Area Walk-By Checklist (AWC)

Plan for Future Seismic Walkdown of Inaccessible Equipment

Peer Review Checklist for SWEL - D. C. Cook Unit 1 and Unit 2

Enclosure 3 to AEP-NRC-2012-87

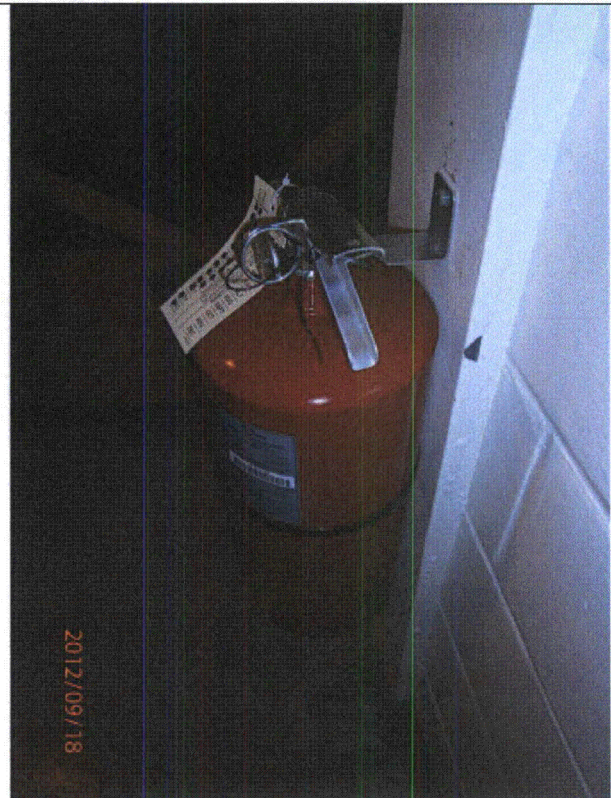
4. Does it appear that the area is free of potentially adverse seismic spatial interactions with other equipment in the area (e.g., ceiling tiles and lighting)? No
Fire extinguishers on short hooks - AR 2012-11669 was issued. Block wall - OK per DWG 12-3253 and 12-3254 Section D-4.

5. Does it appear that the area is free of potentially adverse seismic interactions that could cause flooding or spray in the area? Yes
1-TK-36 is right by panel but well supported

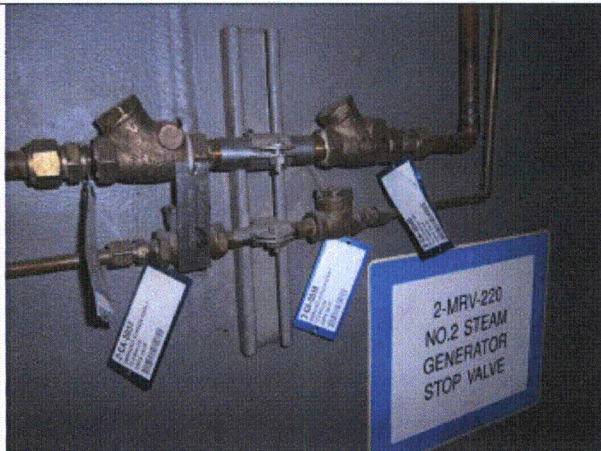
7. Does it appear that the area is free of potentially adverse seismic interactions associated with housekeeping practices, storage of portable equipment, and temporary installations (e.g., scaffolding, lead shielding)? Yes
Scaffold in area - above safety discharge tail pipes - OK

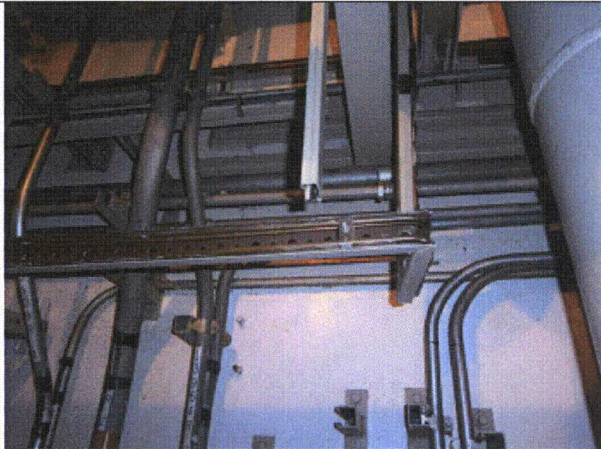
1. Does anchorage of equipment in the area appear to be free of potentially adverse seismic conditions (if visible without necessarily opening cabinets)? Yes
Strainer 2-PW-245-2 Support - lack of thread engagement on 2 bolts on front saddle - has been evaluated by engineering (tag) and is OK by DOC# 01019028

2. Does anchorage of equipment in the area appear to be free of significant degraded conditions? No
Support above valve 2-WMO-753 for control air tubing not well anchored, unistrut coming off the wall and does not have top bolt (does not look like it ever did) - AR 2012-11936 was issued.

5. Does it appear that the area is free of potentially adverse seismic interactions that could cause flooding or spray in the area? No
Approximately 1.5" threaded fire protection pressurized pipe is rod hung and can leak and/or impact other supports in area and may break - AR 2012-11738

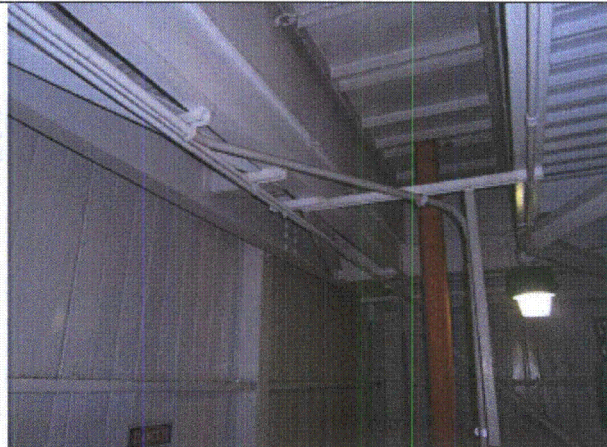
4. Does it appear that the area is free of potentially adverse seismic spatial interactions with other equipment in the area (e.g., ceiling tiles and lighting)? No
Not a safety related area - AR 2012-11762 and AR 2012-11767 were issued.

7. Does it appear that the area is free of potentially adverse seismic interactions associated with housekeeping practices, storage of portable equipment, and temporary installations (e.g., scaffolding, lead shielding)? No
*Not safety related area - AR 2012-11762 and AR 2012-11767 were issued.
Fire extinguishers on short hooks.*
-

8. Have you looked for and found no other seismic conditions that could adversely affect the safety functions of the equipment in the area? No
Not a safety related area - AR 2012-11762 and AR 2012-11767 were issued.

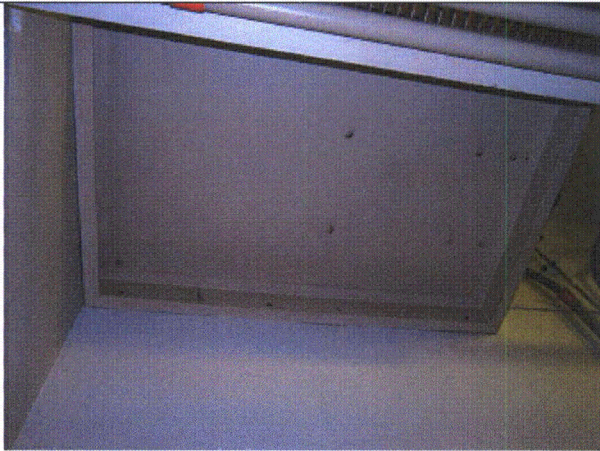
1. Does anchorage of equipment in the area appear to be free of potentially adverse seismic conditions (if visible without necessarily opening cabinets)?
Junction box U bolted (3places) to guard rail of platform Yes

8. Have you looked for and found no other seismic conditions that could adversely affect the safety functions of the equipment in the area? Yes
Twisted angle on top of instrument rack seems to serve no purpose - OK
